STAFF RECOMMENDATION
925 Fatherland Street
November 19, 2018

Application: New Construction—Outbuilding, Detached Accessory Dwelling Unit (DADU)

Description of Project: The applicant proposes an outbuilding to be used as a detached accessory dwelling unit (DADU) at the rear of the lot.

Recommendation Summary: Staff recommends disapproval of the DADU, finding that it does not meet Section III.B.H.1 of the Edgefield Historic Preservation Zoning Overlay design guidelines for massing or roof form, or Section 17.16.030.G.7 for massing and Section 17.16.030.G.8 for design standards of the DADU Ordinance.

Figure 2. Rendering of proposed DADU

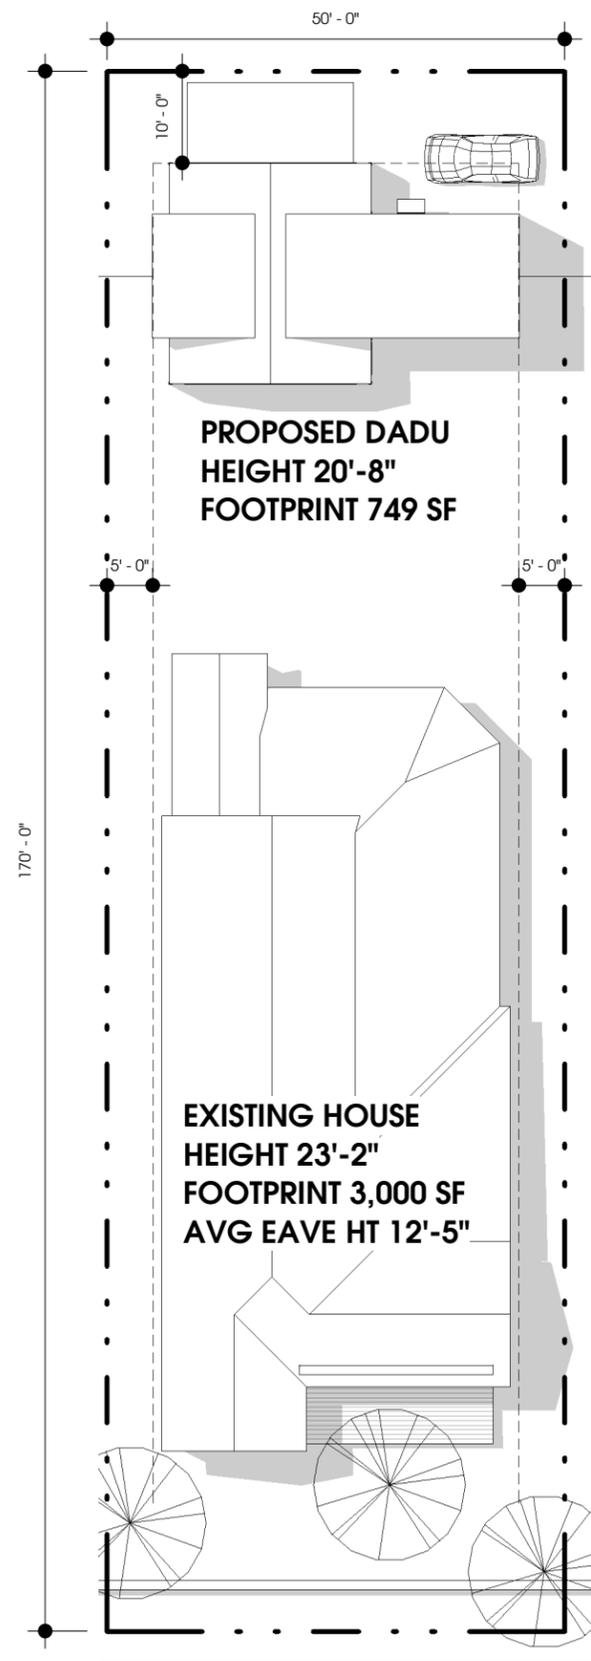
The proposed roof form has a gabled section crossed with a flat roof running the length of the outbuilding. Typically the roof form of an outbuilding should have at least 4/12 pitch, according to the design guidelines. The gabled portion meets this requirement with 10/12 pitch, but the flat roof on such a large section of the outbuilding is not typical of surrounding historic buildings. While a flat roof form is sometimes seen on historic outbuildings, those examples are typically smaller, single-story outbuildings. Staff finds that the application does not meet Section III.B.2.h.1 for roof shape, or Section 17.16.030.G.8 for design standards of the DADU Ordinance.

The proposed structure has a contemporary design which refers to the gable front and wing of the historic home. The form in itself does not make the building incompatible. However, the roof form and eave height are not compatible with surrounding historic buildings, and do not meet Section III.B.h.1 of the design guidelines or Section 17.16.030.G.8 of the Ordinance.

PERSPECTIVES

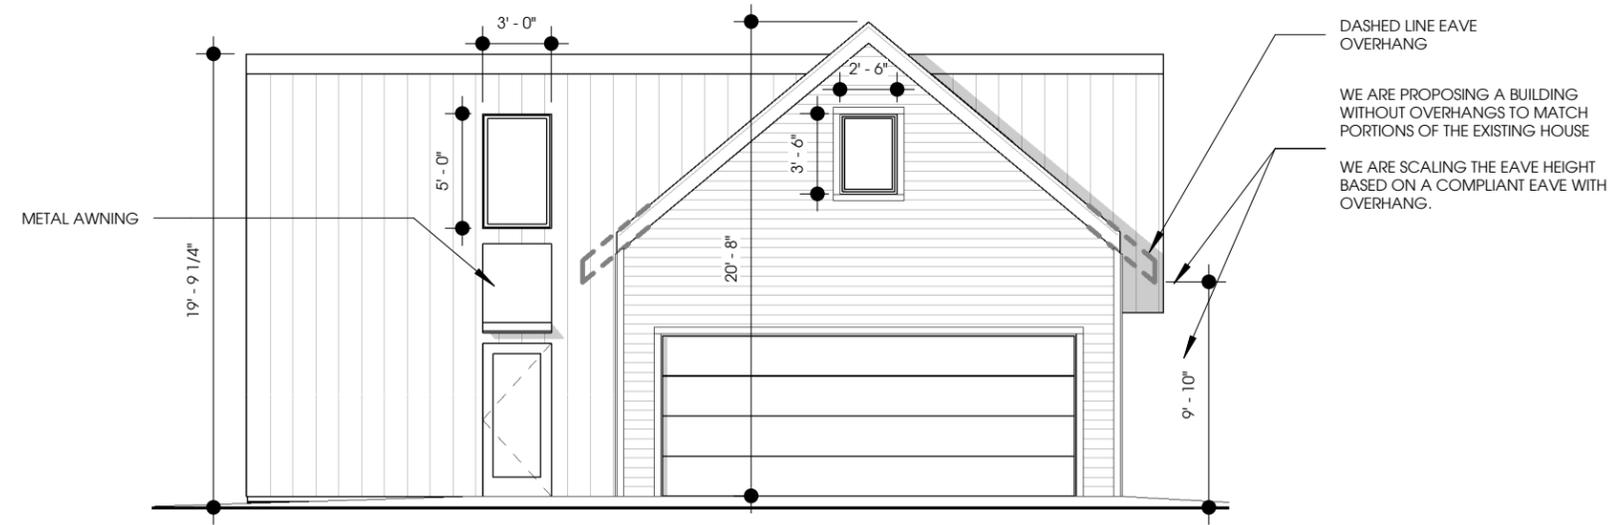
The proposed overall height of twenty feet, eight inches (20' 8") is subordinate to the height of the historic house, which is twenty-three feet and two inches (23' 2"). The eave height of the gabled portion has an eave height of nine feet, ten inches (9' 10"). However the flat-roofed portion is nineteen feet, ten inches (19' 10"); this eave height exceeds the maximum allowed eave height of ten feet (10') and also exceeds that of the house by seven feet and five inches (7' 5").

ELEVATIONS
H2.0

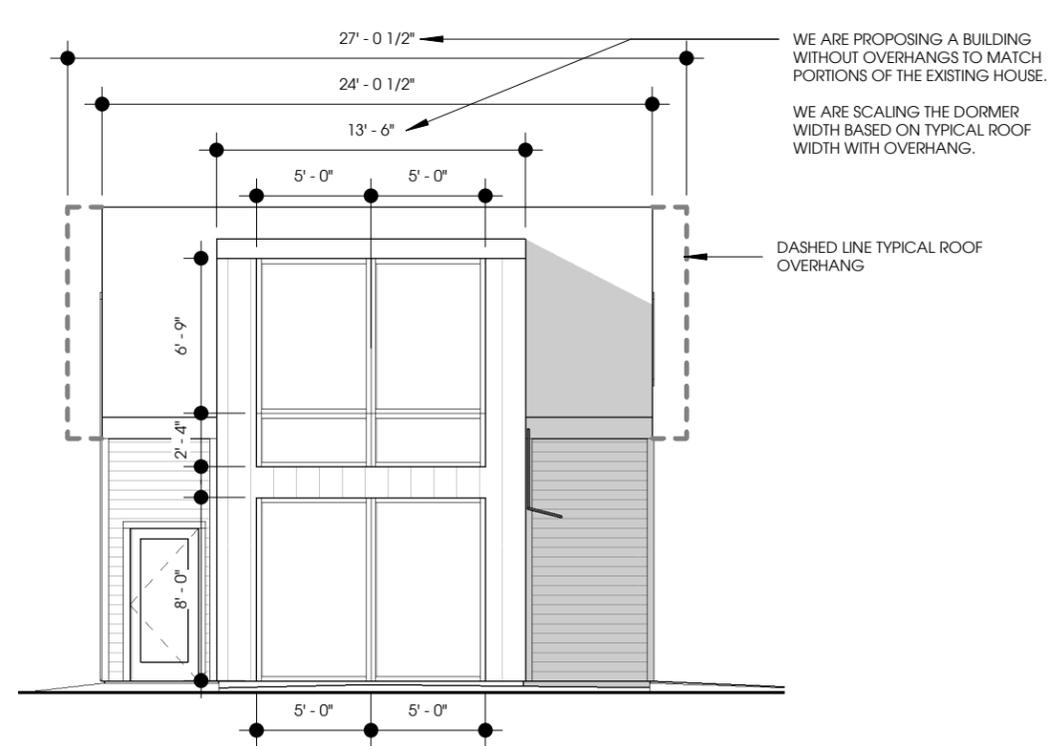
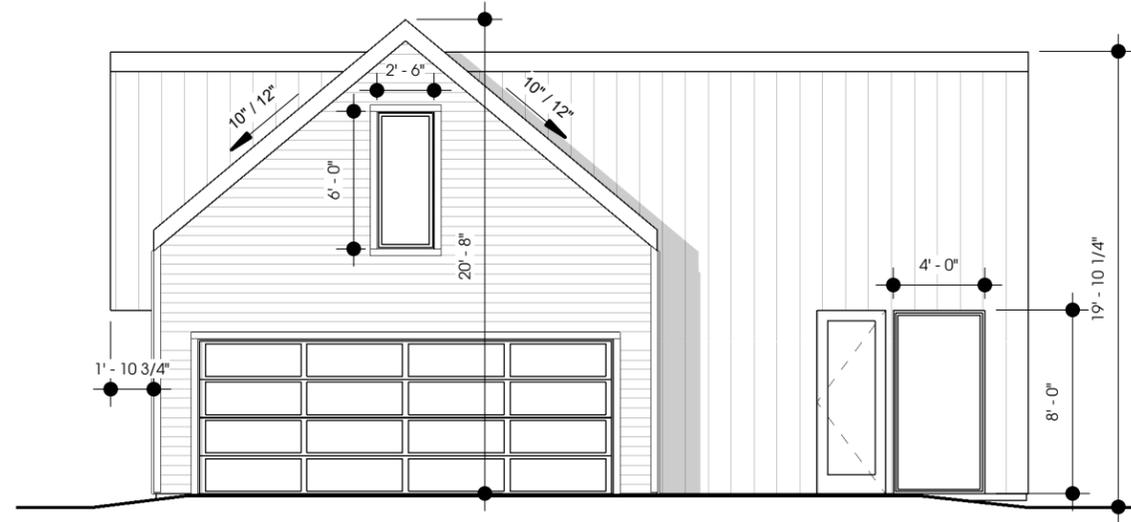
For these reasons, Staff finds that the massing and eave height are not compatible with surrounding historic outbuildings and do not meet the requirements of Section III.B.2.h.1, or Section 17.16.030.G.7 of the DADU Ordinance.
